CCPS RFP # 24-09 – Perryville High School – New Field House Project

ADDENDUM #3

061000 - ROUGH CARPENTRY

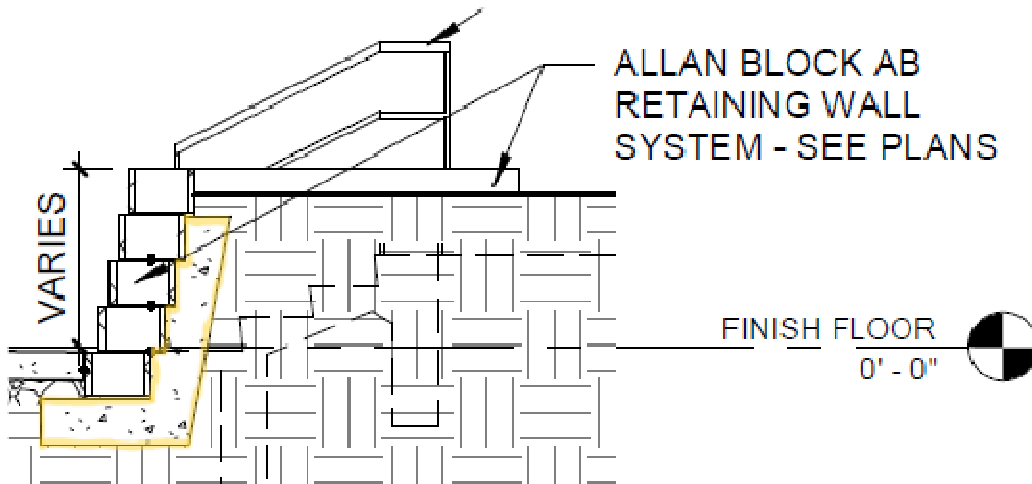
DRAWING G2: Clarification: 1. Non FRT rated trusses are acceptable and preferred

1. FRAMING, BLOCKING, NAILER, FURRING, AND SUPPORTS TO BE ~~CONSTRUCTED FIRE RETARDANT TREATED LUMBER NO. 2 GRADE LUMBER OF ANY SPECIES.~~
2. ALL FASTENERS SHALL BE HOT-DIP GALVANIZED. SCREWS FOR FASTENING TO METAL FRAMING SHALL COMPLY WITH ASTM C 1002.
3. COMPLY WITH AWPA WCD 1, "DETAILS FOR CONVENTIONAL WOOD FRAME CONSTRUCTION"
4. SECURELY ATTACH CARPENTRY TO SUBSTRATE BY ANCHORING AND FASTENING TO COMPLY WITH TABLE 2304.9.3.2 "FASTENING SCHEDULE" OF IBC 2018.
5. COORDINATE WITH STRUCTURAL SPECIFICATIONS.
